# Greenlink Interconnector Technical Review

## Phase 2: Targeted review of issues identified in Phase 1

Commission for Regulation of Utilities

**FINAL REPORT FOR PUBLICATION**

Figure 4.3: Offshore cable unit cost comparison (EPC contract only) (€k per km)

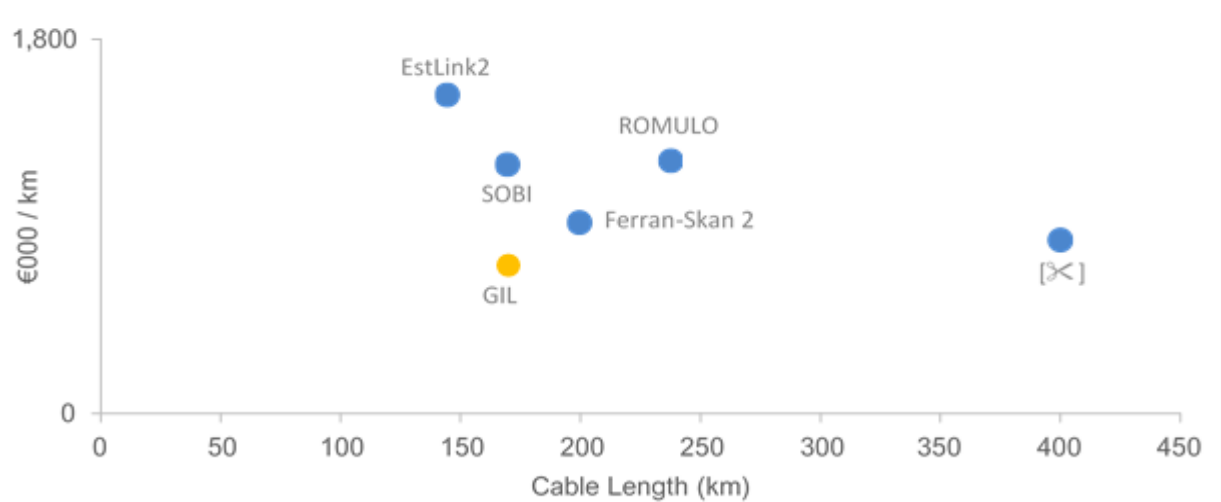
The figures in the table and chart below (adjusted to a 2020 price base) provide a comparison of contracted installed capacity to be built by the EPC contractor under similar conditions.

Figure 4.4: Top-down unit cost comparison against HVDC converter projects (€k per MW)

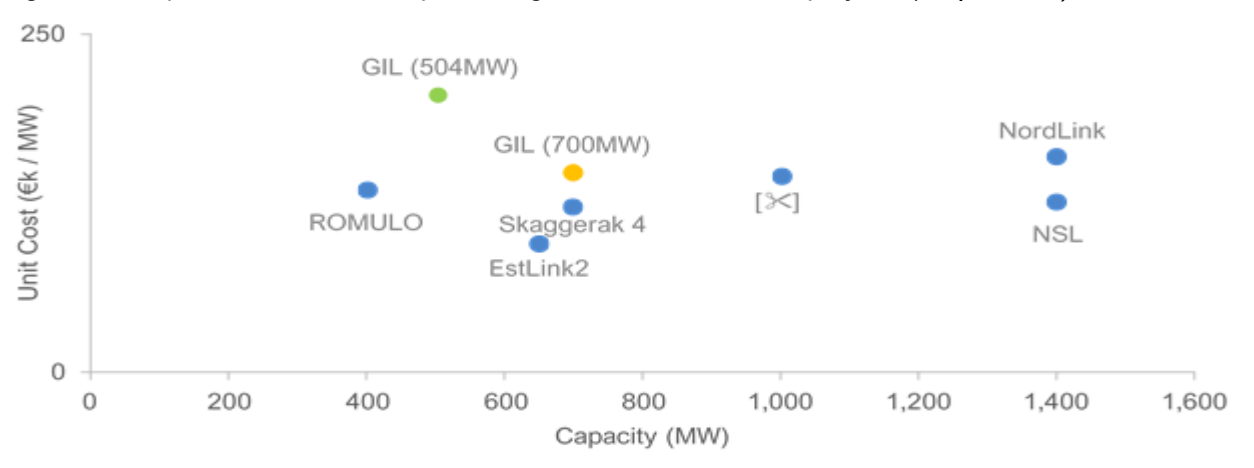
The analysis shows that the GIL HVDC converter EPC cost is substantially above the benchmark range for the base level of capacity (504MW) and remains above the range even if the average unit cost is scaled by the overload capacity (700MW). Of the other projects in the sample, EstLink2 project has the most similar power rating, but is substantially cheaper on a €k per MW basis.

As for the cable analysis, these comparisons should be considered indicative as there are several factors that will have a direct impact on the outturn contract costs with which we compare GIL in the analysis above. However, the cost differential here (as shown in Figures 4.3 and 4.4 below) is substantial and is unlikely to be fully explained by differences between comparators.

Figure 5.1: Comparison of upper and lower limits of Atkins’ benchmarking assessment (Phase 2) against current Greenlink O&M costs (€m) over 25-year operational period.

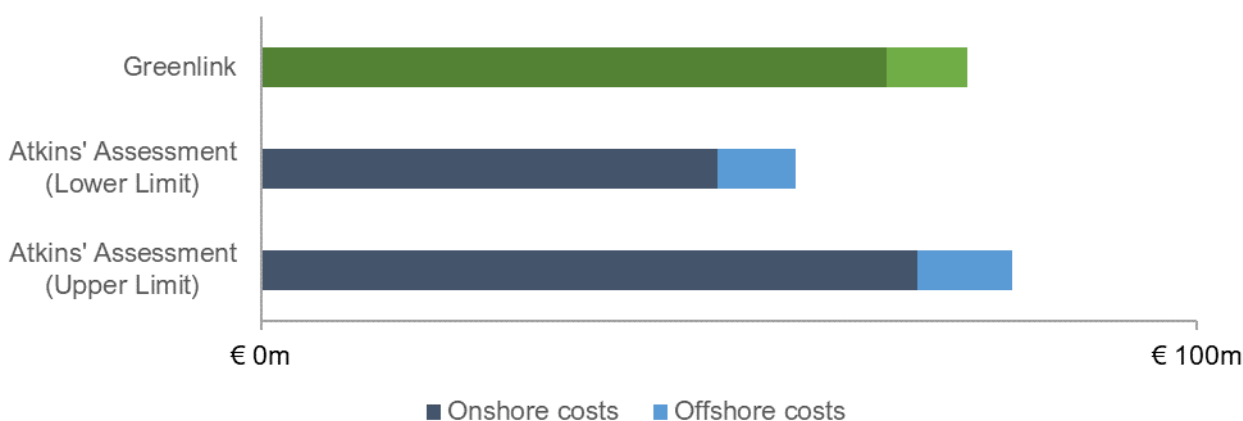
Table 5.3: Comparison of Atkins’ Phase 2 benchmark assessment versus current Greenlink O&M costs (€m) over 25 year asset lifetime

Figure 5.2: Annualised opex comparison

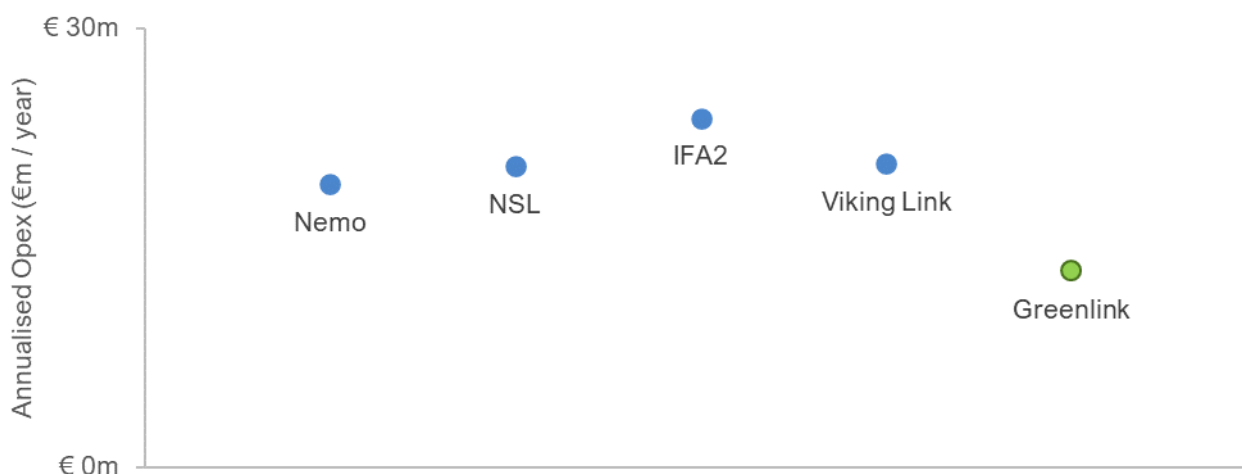
provide a ‘top-down’ view on opex in the round. This is a simple comparison of total opex costs for each comparator against GIL’s projected total opex. A summary of Atkins’ top-down benchmarking of OPEX costs is provided in Table 5.4 and illustrated in Figure 5.2.
